Morris Arco 26 #002 SWD

API #: 30-015-29258

Action 64335

Operator:	OGRID:
Spur Energy Partners LLC	328947
9655 Katy Freeway	Action Number:
Houston, TX 77024	64335
	Action Type:
	[C-103] NOI Workover (C-103G)

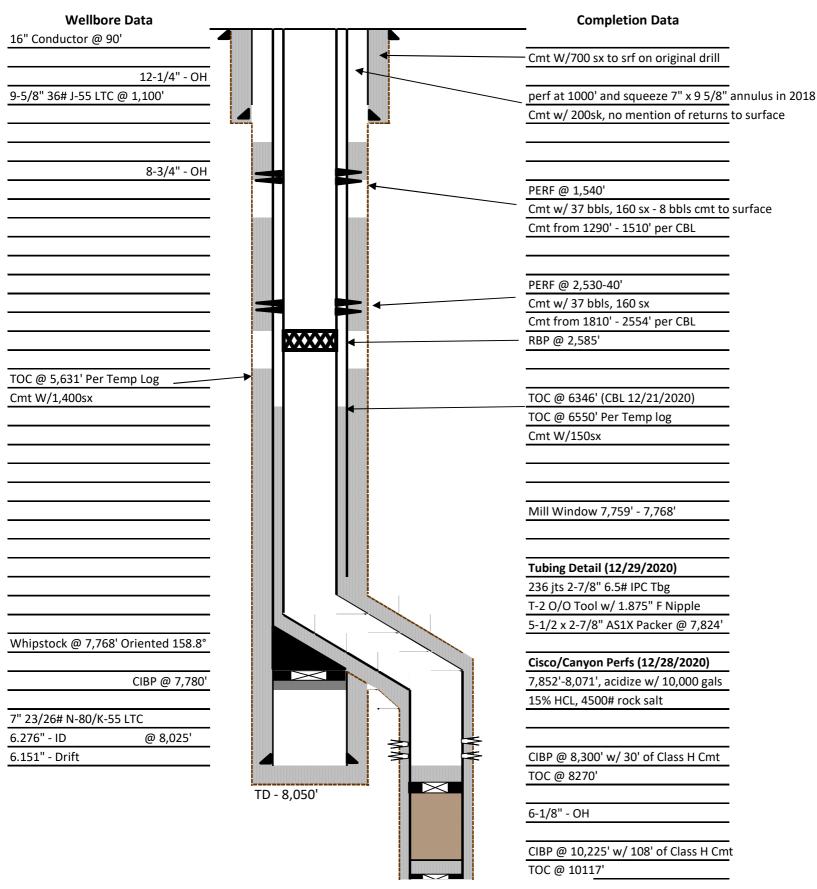
Created	Condition	Condition
Ву		Date
dmcclure	Operator shall notice the Division on at least the previous day and at least 12 hours prior to conducting cement operations.	11/30/2021
dmcclure	Operator shall record and report all cement volumes to the Division.	11/30/2021
dmcclure	Operator shall monitor and record the 9-5/8 casing pressure for at least 24 hours after a successful pressure test of the 5-1/2 casing referenced by item 6 above.	11/30/2021
dmcclure	Approval to recommence injection is not granted by this sundry and Operator shall NOT recommence injection until it has been sought and granted in a follow up sundry which shall include	11/30/2021
	the results of the work and tests authorized by this sundry.
